**US Army Corps
of Engineers**
Tulsa District

DROUGHT CONTINGENCY PLAN

DROUGHT CONTINGENCY PLAN
FOR
CANADIAN RIVER BASIN

Subject: Review Comments, Canadian River Basin Drought Contingency Plan,

Figure 3-1: Canadian River Basin.

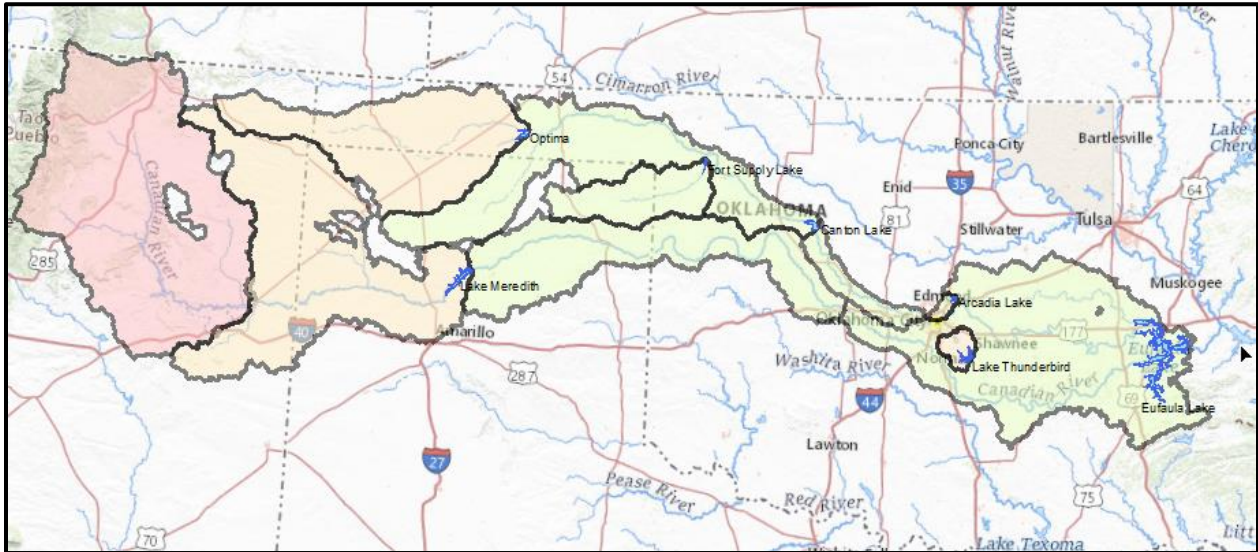
- 12 3-2 Figure 3-1. Canadian River Basin Map. Add bolder borders to delineate the watershed boundaries. Also provide a Footnote that states which color portion is “Non-Contributing drainage areas” and which are “Contributing drainage areas” into the Tulsa District Projects. Also label Ute Lake near Logan, NM as this is where one of the Non-Contributing basin areas starts downstream of the dam. Correct as necessary. FJ

The following change has been applied.

“Note:

Green shaded areas are watersheds to Eufaula Lake, Arcadia Lake, Canton Lake and Fort Supply Lake.

Brown shaded areas are watersheds to Optima Lake, Meredith Lake and Thunderbird Lake.

Red shaded areas are watersheds to Conchas Reservoir and Ute Reservoir outside the Tulsa District’s area of operation.

White shaded areas are non-contributing areas to the Lakes in the Canadian River Watershed.

Lake Meredith and Lake Thunderbird conservation pools are managed by Bureau of Reclamation and are excluded from this manual.”

Figure 4-1: Drought Monitor Map for the Week of November 12, 2019.

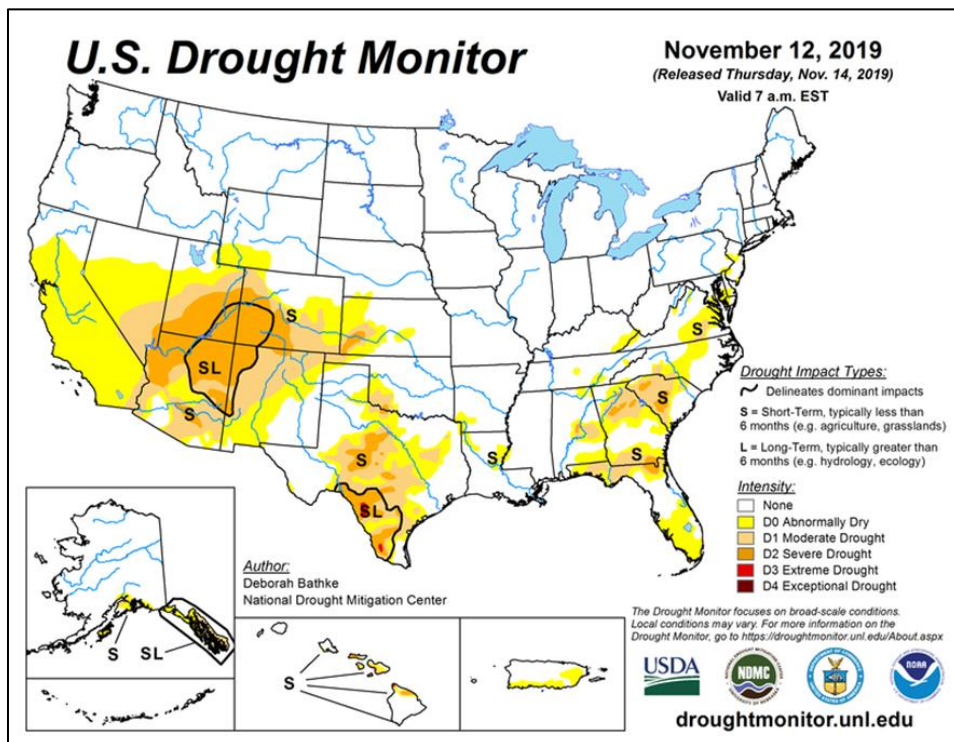
3. [P. 4-1] “The NIDIS publishes weekly drought maps indicating current drought conditions (Figure 4-1), drought impacts, Palmer Drought Severity Index (PDSI), and other drought parameters.”

Recommend stating that “The U.S. Drought Monitor is a weekly publication is produced jointly by the National Drought Mitigation Center (NDMC) at the University of Nebraska-Lincoln, the National Oceanic and Atmospheric Administration (NOAA), and the U.S. Department of Agriculture (USDA). See Figure 4-1 for an example from the week of November 12, 2019.”

Change applied. GS
